Design Review Subcommittee (DRSC)

SUBJECT: **Minor Architectural Permit (MAP) 22-119, Lohmann Balcony, 101 Via Bellas Artes**, a request to replace a wrought iron guardrail with partial glass guardrail on the alcove of a second story balcony at the corner of Via Bellas Artes and Via Artemesia, an existing single family residence within the Marblehead Coastal Specific Plan.

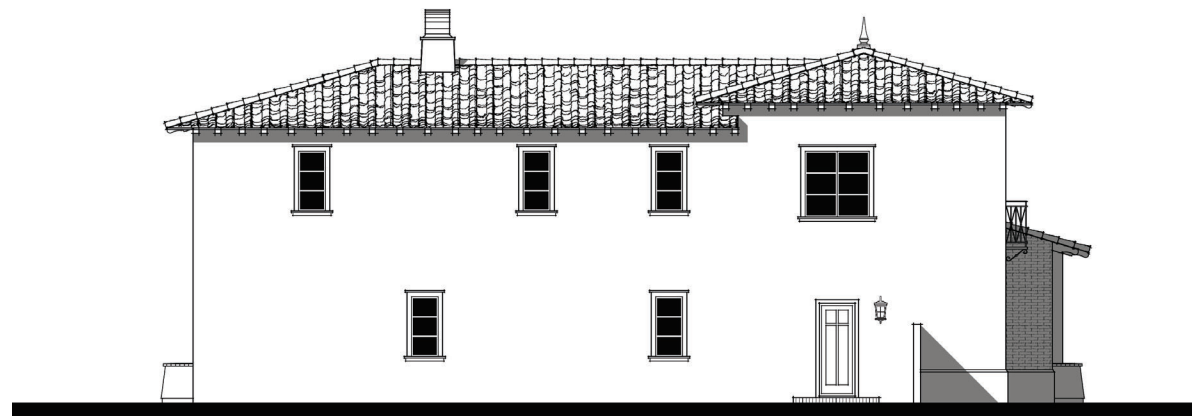
The applicant installed a full glass guardrail on the alcove deck, however, and is requesting approval of the as-built condition, which is a deviation from the original approval that specified a partial glass rail with wrought iron facing on Via Artemesia. Currently, this existing. The Applicant installed the full glass as a result of his wrought iron supplier going out of business (2019) at the time of construction. This required a revision to the existing building permit, and resulted in the Minor Architectural Permit (MAP). Senior staff issued a letter stating that staff was not able to approve the revision for the rail administratively. The glass rail would be a significant modification from the approved architecture for the residential structures, which cannot be approved administratively.

The applicant is requesting approval of a Minor Architectural Permit for an alteration of an issued building permit B18-1761. The modification moves away from the approved aesthetics of the originally approved project. The revised project is not consistent with the Spanish architectural style and does not further the goal of characterizing the theme of a “Spanish village by the Sea”, as stipulated by General Plan Policy LU 1.04.(Attachment 2). (See Attachment 3)

NEW
Change partial glass rail to Full Glass rail system - new supplier (CVG)
